# MASTERTON DISTRICT COUNCIL

Application for Resource Consent under Section 88 of the Resource Management Act 1991

Application No	RM220130
Consent Type	Land Use
Applicant	SOHO GROUP LIMITED
Proposal	A 10-unit residential development that exceeds the number of dwellings permitted per site
Location	67 Renall Street, Masterton
Legal Description	Lots 1 & 2 DP 29960 contained within Record of Title WN54C/104
Zone	Urban - Residential
Activity Status	Restricted Discretionary - Rule 5.5.4 (a)
Decision	<b>Granted</b> under Delegated Authority - <b>28/06/2023</b>

Figure 1: Architectural Plan Set, RC5.01, Rev B

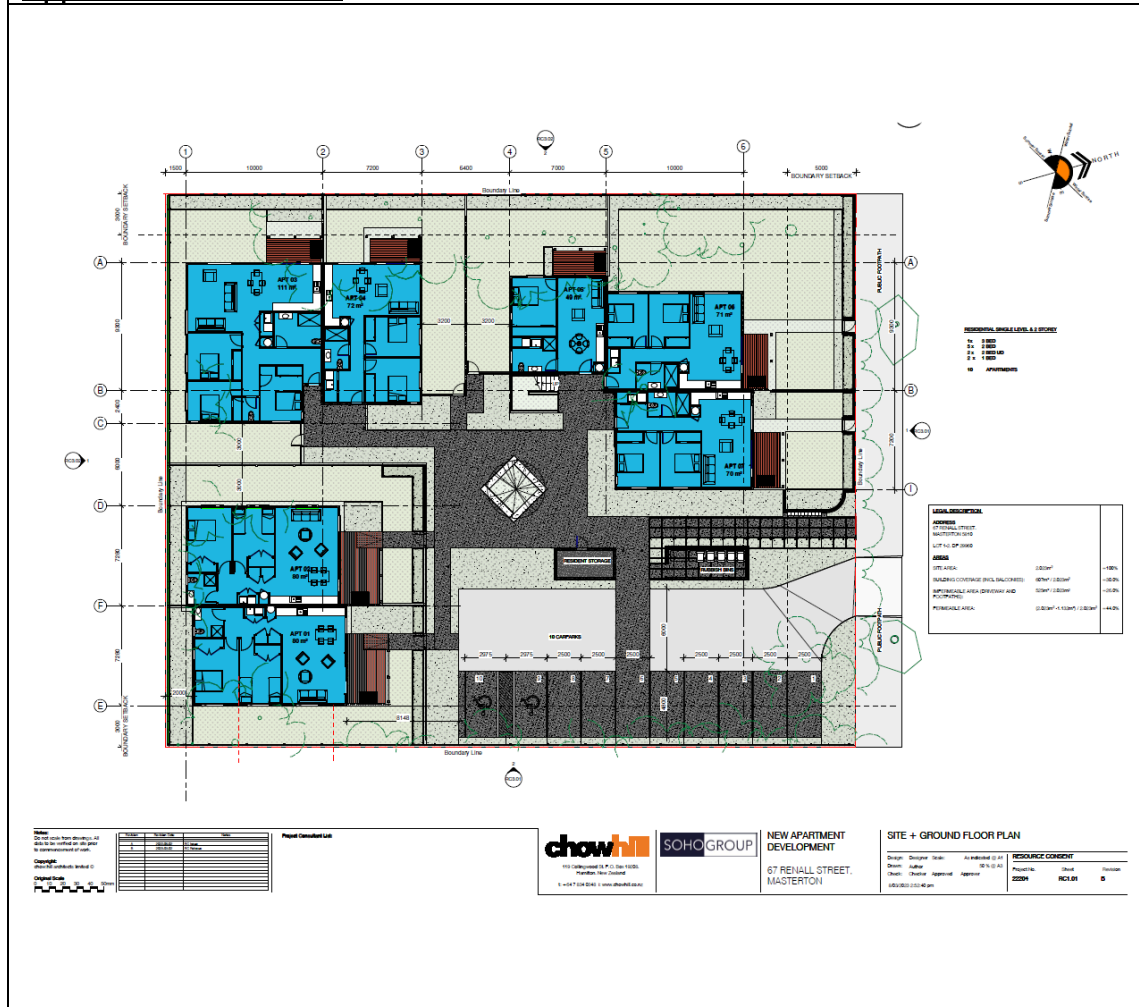
- 1.1 The proposal seeks to construct a 10-unit residential development (in three “blocks”) that exceeds the number of dwellings permitted under the Wairarapa Combined District Plan (2011)(“WCDP”). The development comprises a two-storey, front block of six units, and two single-storey, rear blocks of two units. The development contains a car park of 10 parking spaces to the east of the subject site, and a communal common courtyard area and storage areas (for rubbish bins and residents’ belongings) toward the centre of the site. The proposed units are set amongst well-established landscaping, as depicted in the architectural renders below (Figure 1).
